Planning Officer's Report – LDCA MARCH 2025

APPLICATION	2025/06 – Replacement of lights on Jacobs Ladder, comprising construction of 92 new concrete bases to facilitate the vertical installation of new bollard lights
PERMISSION SOUGHT	Full Permission
REGISTERED	28 January 2025
APPLICANT	Street Light Section, St Helena Government
PARCEL	JT170076
LOCALITY	Jacobs Ladder
ZONE	Intermediate/Coastal
CONSERVATION AREA	Heritage Coast
CURRENT USE	Historic Landmark
PUBLICITY	The application was advertised as follows: <ul style="list-style-type: none">▪ The Sentinel Newspaper on 30 January 2025▪ A site notice displayed in accordance with Regulations.
EXPIRY	13 February 2025
REPRESENTATIONS	Three Received
DECISION ROUTE	Delegated / LDCA / EXCO

Diagram 4: Section A Showing Proposed Position of Lights

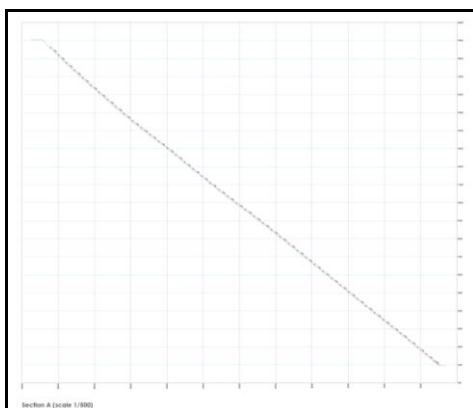
It is also of concern that there is very limited drawing information provided. For example there is no section provided across the staircase. If there was, it would show the longitudinal beam against the steps is likely to create a shadow across half of each step meaning the lighting will far less efficient than shown. This may lead to the bollards being increased in height, again adversely affecting appearance.

Diagram 7: Installation Schematic Drawing 1 – Artist’s Impression

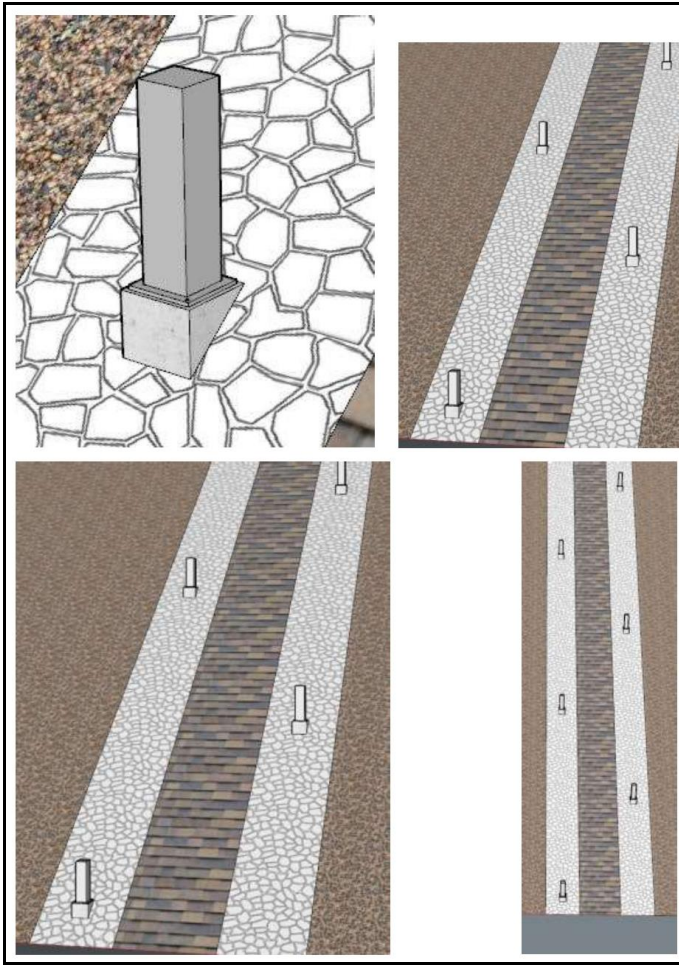
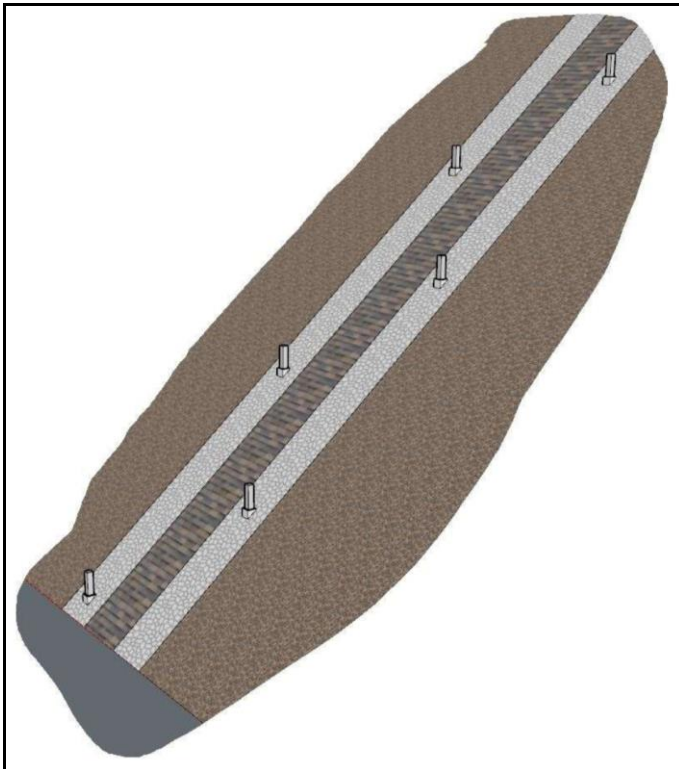
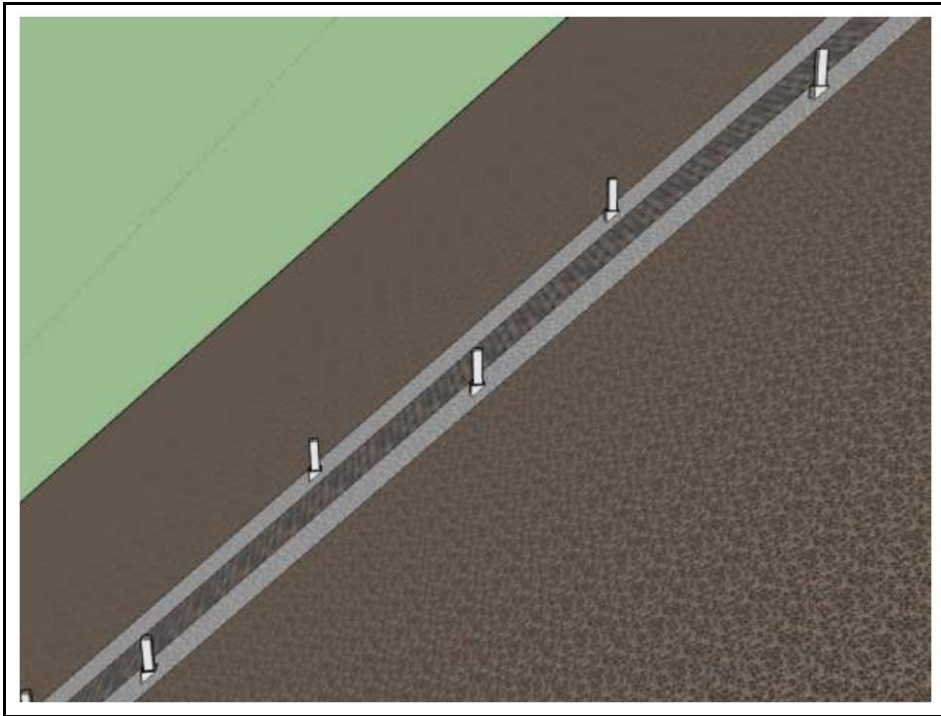
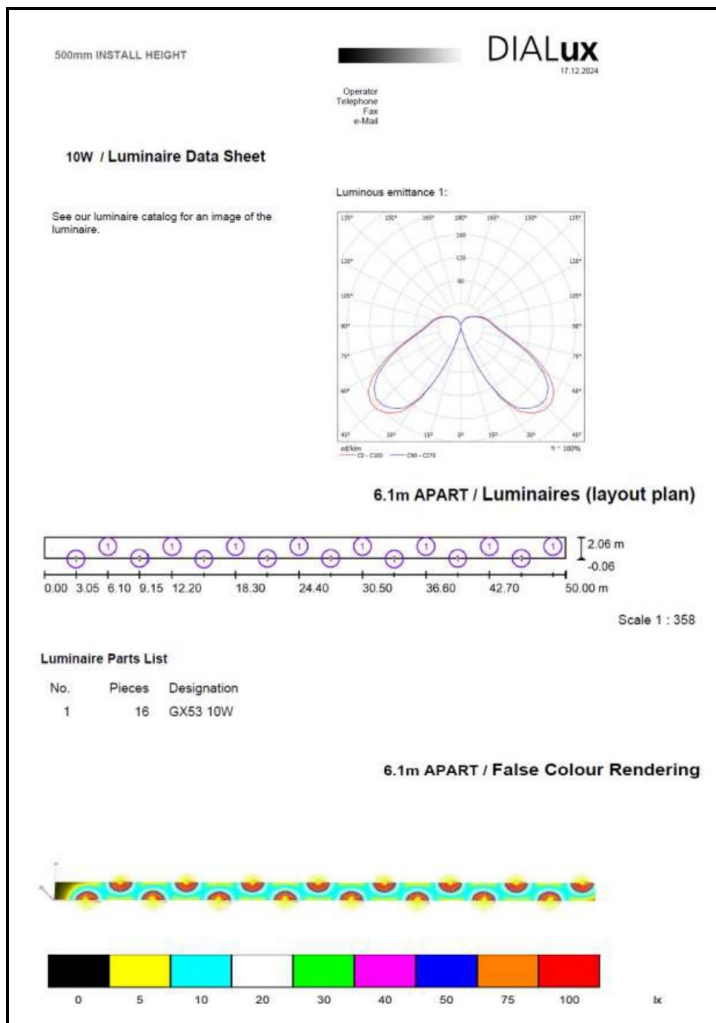
The proposed concrete blocks to support the proposed lighting bollards are shown without detail. It is unlikely they will sit on top of the Inclined Plane as depicted. They

will need to be dug-in somehow but there is no detail. How does this relate to 'preserved in situ'?

It would also seem the blocks shown will be too small as the anchor bolts will be so close to the edge that the corners will break off. Therefore they will need to be several inches wider. If they are wider, they will also be higher due to the angle. As a result the blocks depicted will be larger than shown in the application and will therefore have a greater adverse impact on the appearance of the Ladder.

In addressing the representations of concerned members of the public, as this light fitting design is confirmed as 'Dark Skies Compliant' within its manufacturer's specification, albeit Dark Skies Legislation has yet to be enacted, this meets with Saint Helena Government's (SHG) aspiration in the event legislation becomes enacted. Concern was also raised with regards to the concrete bases and the excavation entailed, a condition has been added to ensure details are submitted to show how the bases will be constructed to ensure the works are carried out sensitively to the inclined plane.
